RE: NOV #85-4-15-1, Abatement Response Plans received on September 20, 1985, Soldier Creek Coal Company, Soldier Canyon Mine, ACT/007/018

Soldier Creek submitted abatement plans in response to a violation concerning failure to construct sediment pond according to approved mine plans. These abatement plans modify the existing plan by placing additional riprap material on the toe of the outslope of the sediment pond and in the perennial stream channel.

PROJECT NAME SOLDIER CREEK SEDIMENT POND - R. HARDEN

Data Documents SS:338-1478-11

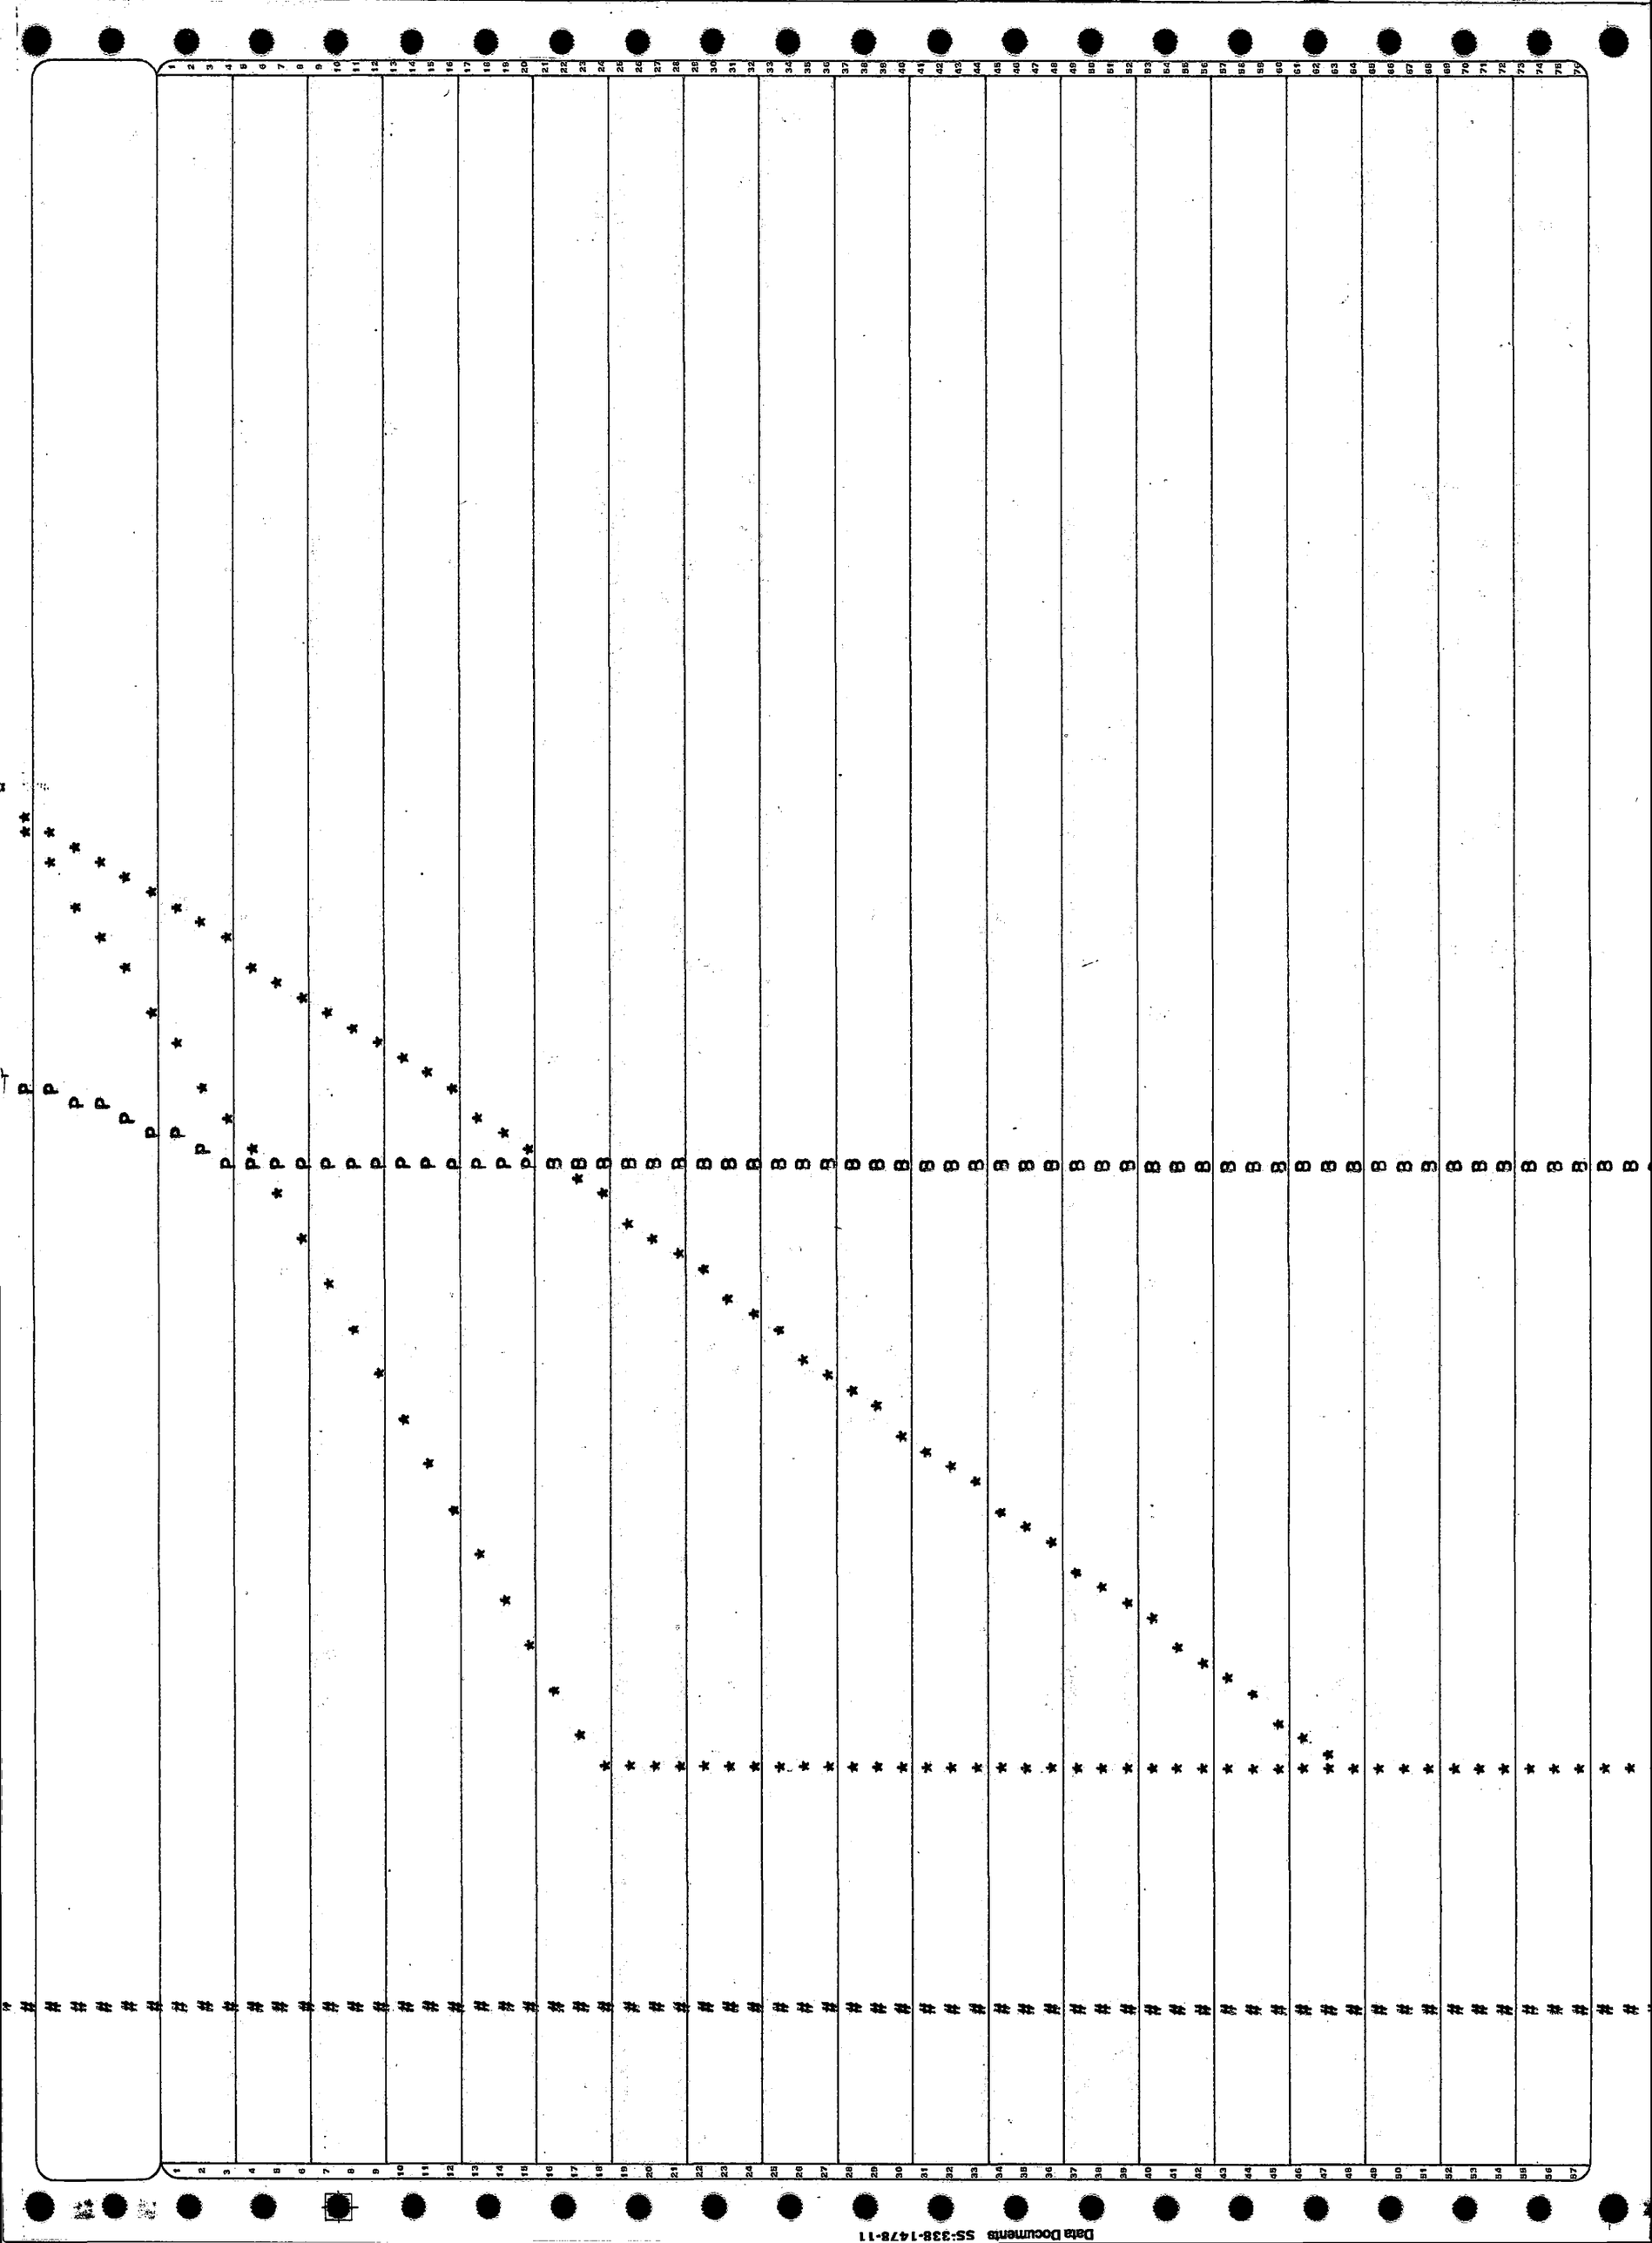
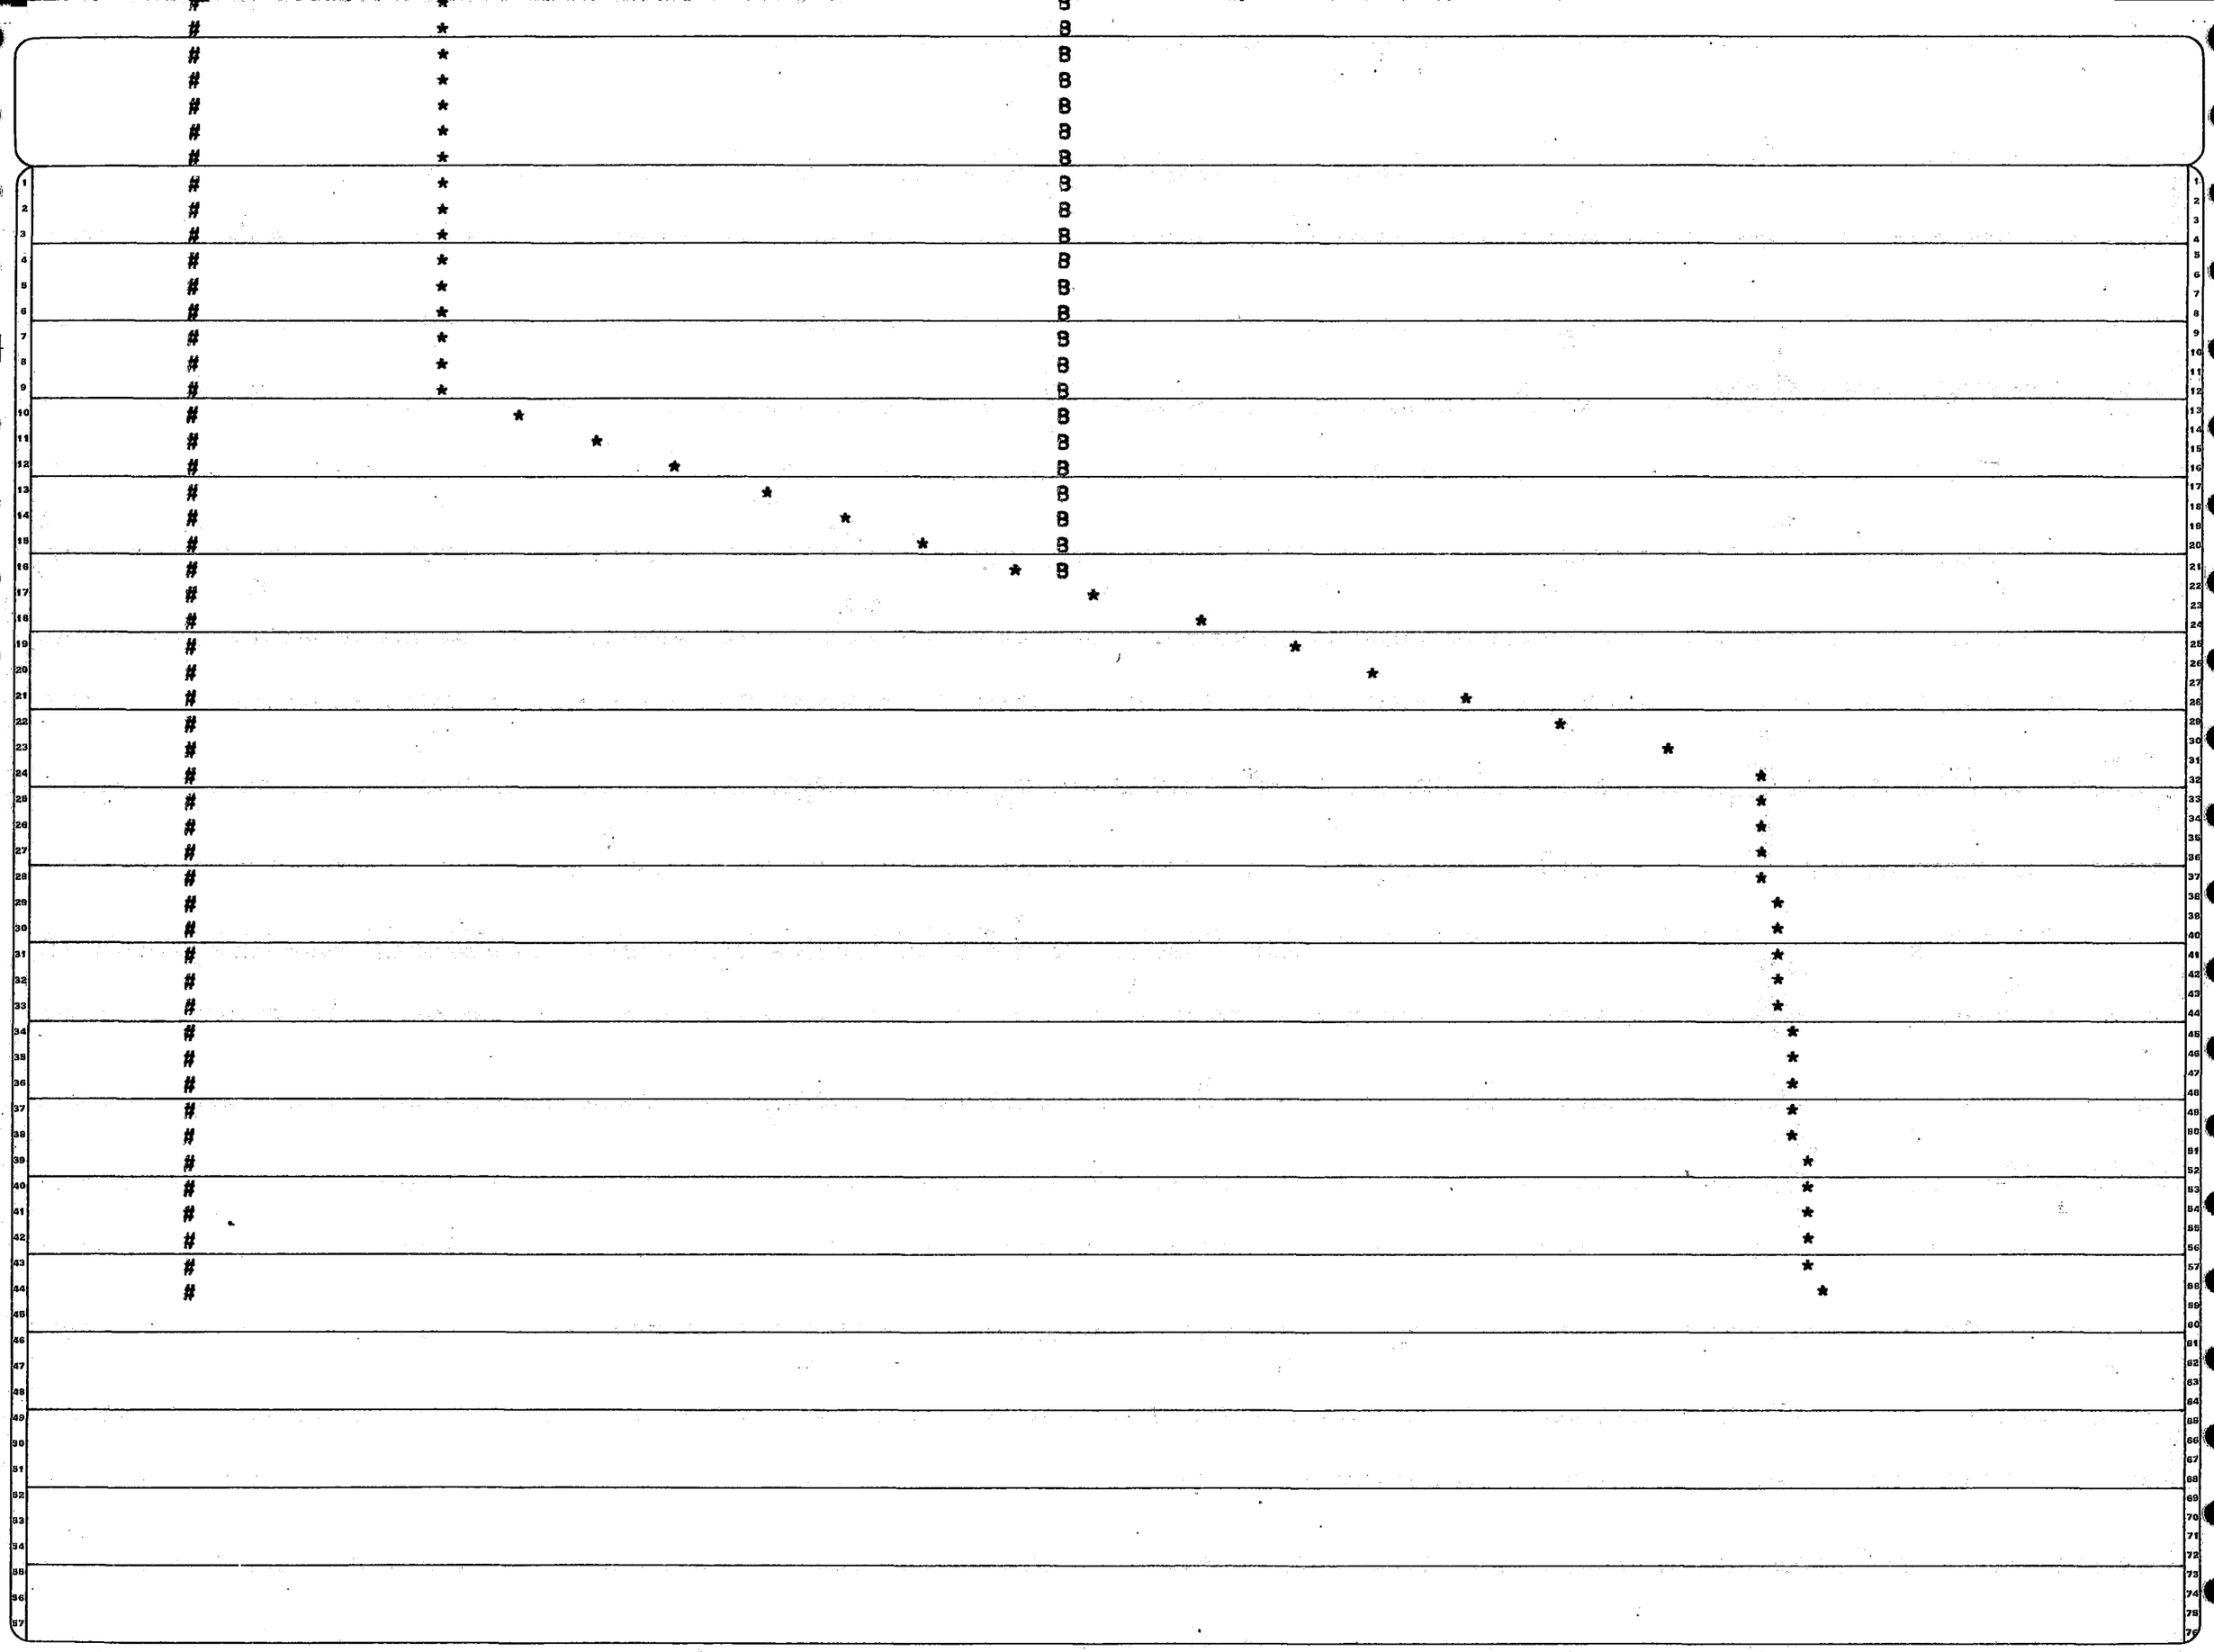
3. Calculations for the stability of the sediment pond are not sufficient to show stability. Calculations by the Division indicate that the proposed has a factor of safety which is considerably less than 1.5. Design of embankments, including the opposite stream channel, must be revised and complete stability analysis of the embankments must be provided to ensure stability of 1.5 static.

Calculations regarding the stability of the sediment pond and stream channel embankments are as attached to this memo(computer printouts).
